**STS-109  
FLIGHT READINESS REVIEW**

**FEBRUARY 14, 2002**

**Orbiter**

Figure 3

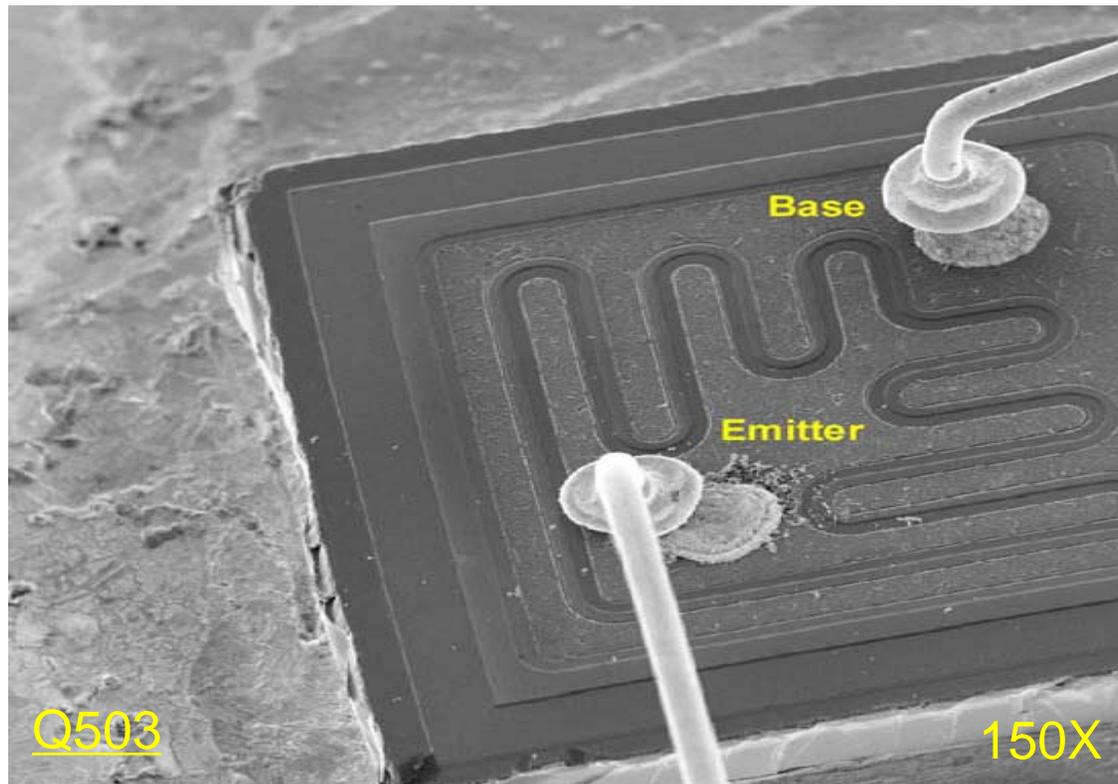
### SEM of Detached Base and Emitter Bond Wires

Figure 4

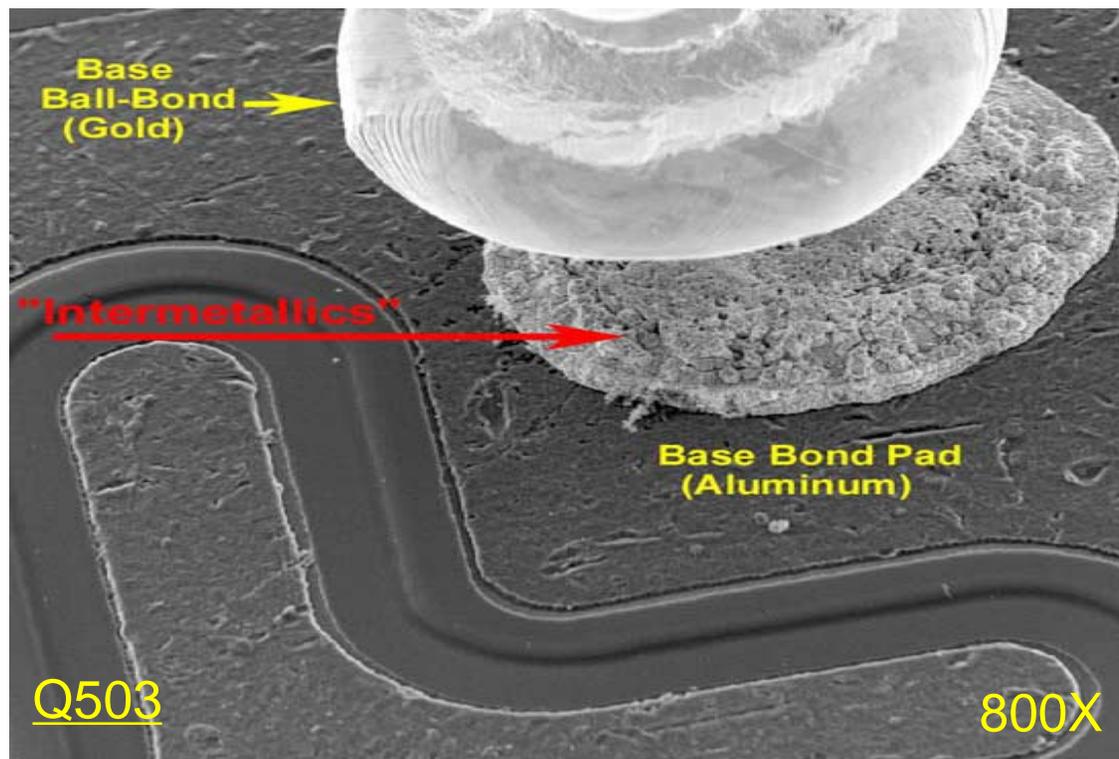
### SEM Showing Intermetallics In Bond Region

Figure 5

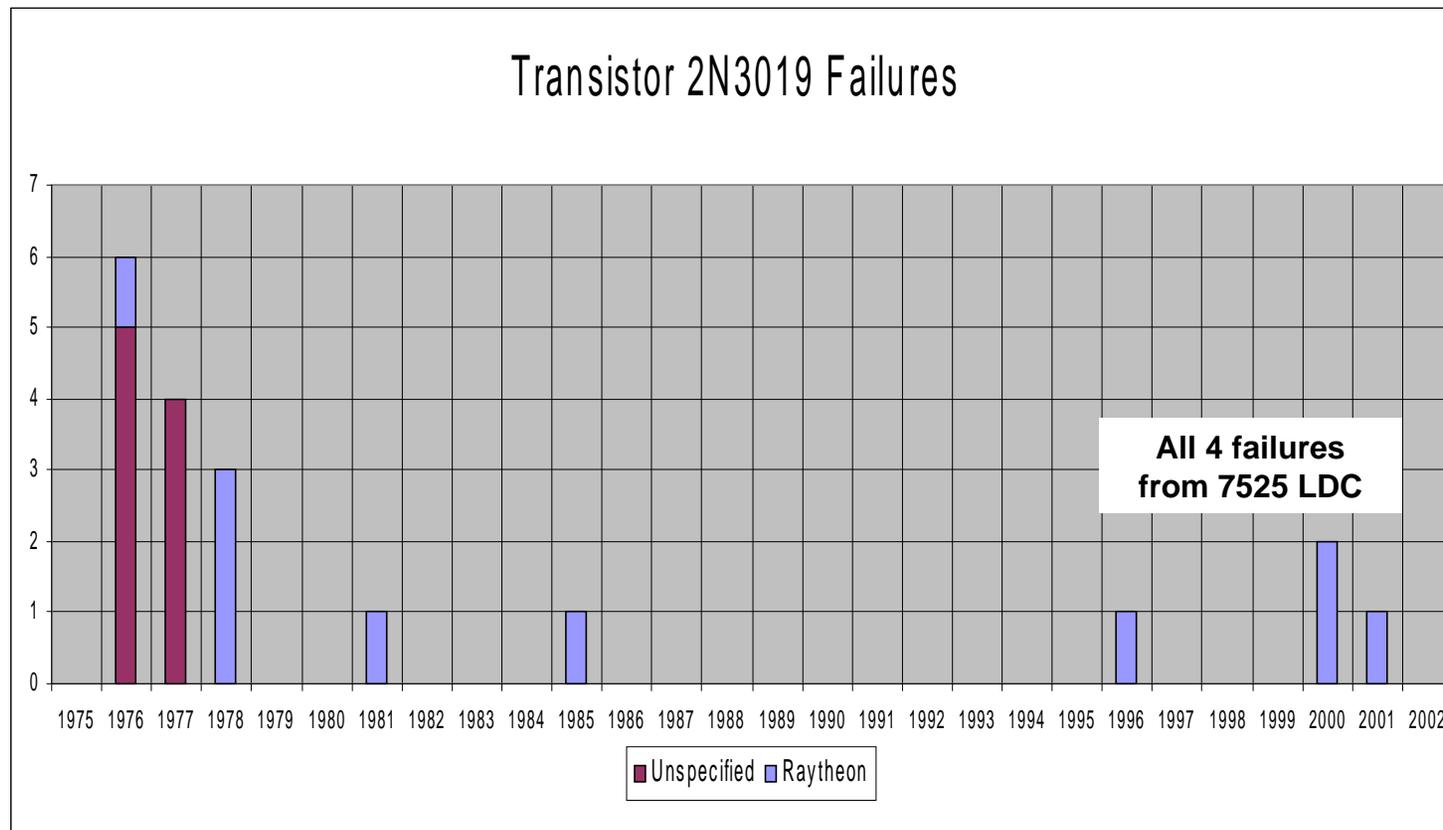
- Conducted PRACA history search to identify all 2N3019 transistor failures (refer to Figure 5)
  - Identified 16 CARs documenting 19 transistor failures (various manufacturers)
  - Due to incomplete documentation, only 8 CARs confirmed to involve Raytheon transistors
  - No records contained information regarding destructive failure analysis
    - One record indicated that transistor was de-lidded and photographed, but in most cases transistors were simply R&R'd
- Four recent failures led us to investigate LDC 7525 as a potential lot problem
  - Aerospace Corporation failure database
  - GIDEPs
  - Additional failure analysis at NSLD
  - Destructive testing of randomly selected parts at Hi-Rel
